DESIGN REVIEW & PRESERVATION BOARD
1231 "T" Street - SACRAMENTO, CALIFORNIA 95814

LOCATION: 2217 I Street

PROPOSAL: New Construction, Five Unit Apartment Building

PB 85-034

SITE PLAN / FIRST FLOOR PLAN

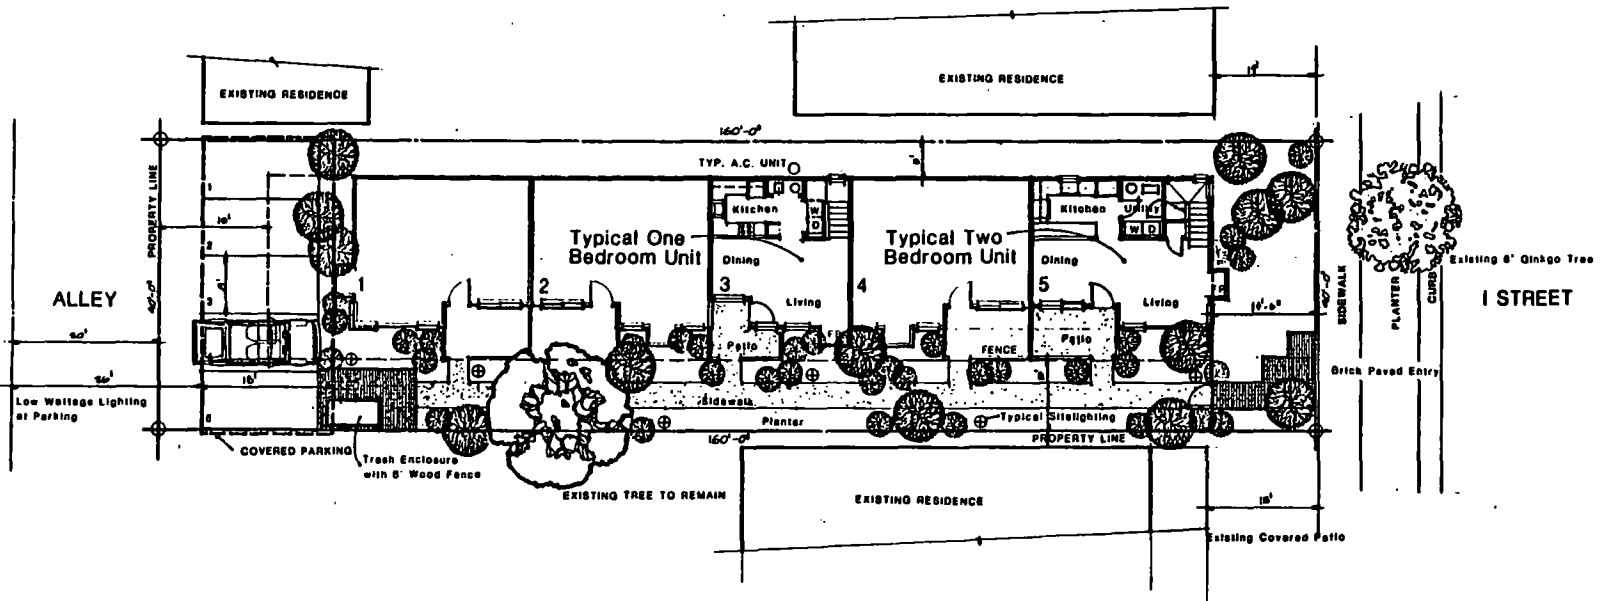
4. The applicant has proposed all entries to access the building from the west elevation. In conjunction to that a security fence has been placed along the west side and the front and back of the structure providing limited access to the building. Staff feels that it would be appropriate for the front unit to be turned 90 degrees so that the fenestration in the dining room and living room and the second floor bedroom would face toward the street. Staff would suggest that in order to achieve this without adding an economical problem to the project, the following take place.

- a. the two, two bedroom units at the front of the building be moved toward the rear;
 - b. the one bedroom unit in the middle of the building be moved to the front;

- c. the one bedroom unit be turned 90 degrees so that the dining and living room face out toward the street;

d. in place of the patio floor as shown on the site plan a raised front porch be designed which would allow access to the entry door as proposed on the plan. The front porch/patio could be placed so that the security fence was between the patio and the front of the building allowing the one bedroom unit to have an equal amount of security as the other two bedroom units.

1. ~~That the two two bedroom units be moved back on the site and exchange places with the one bedroom unit, which would be placed at the front of the building.~~ The front elevation to be designed with windows and doors facing toward the street.

2. ~~That the one bedroom unit be turned 90 degrees.~~
A sence of porch or entry to be provided at front door.
3. ~~That in place of the proposed patio a wooden porch floor be provided.~~

4. That the ^{front} ~~one bedroom~~ unit be ^{raised to be comparable to the height of} ~~place on~~ a concrete foundation with wood floor joists. ~~Unit to have a covered entry.~~

9. The security fence be moved back from its present location toward the rear of the site a sufficient amount to provide security to the front living unit and yet open up a greater expanse of view to the covered porch of the building located immediately to the west.

EAST ELEVATION

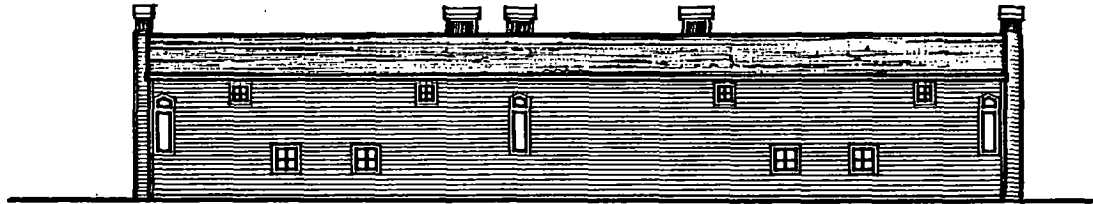
2. The west elevation of the building has a considerable amount of movement and will have a great deal of interest when viewed from the adjacent structure or the street. The east elevation does not have the architectural interest and movement as provided on the west elevation. The east elevation is a continuous facade from the front to the rear of the building. In conjunction with the continuous ridgeline of the roof it presents a monotonous face to the building located to the east. The location of the fenestration in the east elevation is interesting and as the applicant has stated, the proximity of the proposed building to the adjacent structure will only allow the residents of the adjacent structure to see a portion of the building at one time.

10. That the applicant redesign the window bayes on the west front elevation and the west rear elevation to have more interest than that of a square rectangular extention placed on the building.
